Access Compliance Report

Public Rights-of-Way

(Pedestrian Signals)

Intersection ID: N/A	Main Street:	Cross Street: N/A	Location: N/A
ADA ID: D5BCADA10920	Signal Type: Two Push Buttons-APS	Overall Compliance: No	Severity Score: BTN 1:N/A BTN 2: N/A No BTN: N/A
Codes/Mitigation Info/Possible Solution		Field Measurements/Component Compliance

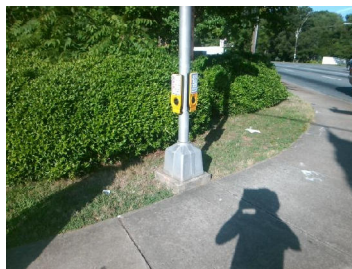
Surveyor Notes: TEXT HT 5/16

PROW/ADA: R410.6, R209.1, TMUTCD 4e.08, R404.2, R406.2,

Possible Solutions: Remove & Replace Replace APS Button With New APS Button. Remove and Replace Clear Space. Replace Signal Push Button With APS Button on New Post. Remove & Replace Sign.
